# <u>Halesowen Area Committee – 14<sup>th</sup> September 2005</u>

## Report of the Director of The Urban Environment

## A458 Halesowen to Stourbridge Bus Showcase Route No. 9

## **Purpose of Report**

# Appendix B - MAP

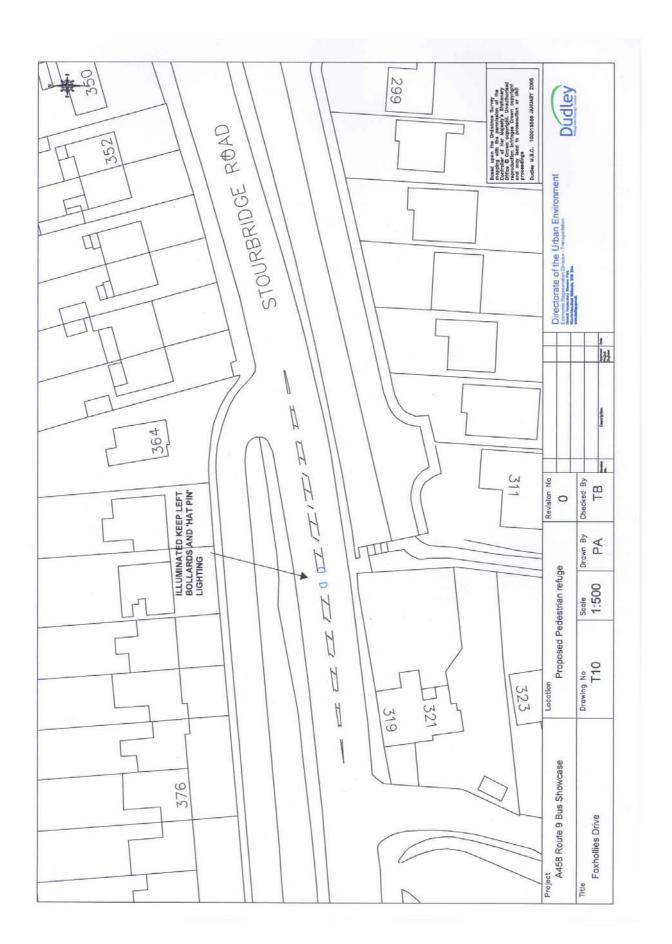
- A pedestrian refuge near Foxhollies Drive is proposed to improve pedestrian access to bus stops. (Appendix B Map).
- There are no pedestrian crossing facilities between the eastbound bus stop in Belle Vale and the eastbound bus stop near Witley Avenue.

- 9 Members were consulted on the 31<sup>st</sup> May informing them of the proposed refuge. No residents would be directly affected by the proposed refuge as there are no direct frontages onto the A458 in this location.
- A safety audit was carried out on the proposed refuge which found no problems with the proposal.
- No adverse comments have been received from the emergency services, Travel West Midlands and Centro.

- The Area Committee support the implementation of the pedestrian refuge in Stourbridge Road near Foxhollies Drive as shown on Drawing No. T10 attached. (Appendix B Map).
- In an effort to avoid delay to the implementation of the above proposals the Area Committee agree that final decisions on any unmet concerns be made by the Cabinet Member for Transportation in consultation with the Director of the Urban Environment.
- Given the problems and concerns identified through the consultation exercise, and the difficulties of siting the crossing close to the actual desire line for pedestrians, the provision of a zebra crossing in Windmill Hill as shown in Drawing No. T11r1 attached, be abandoned. (Appendix C Map).
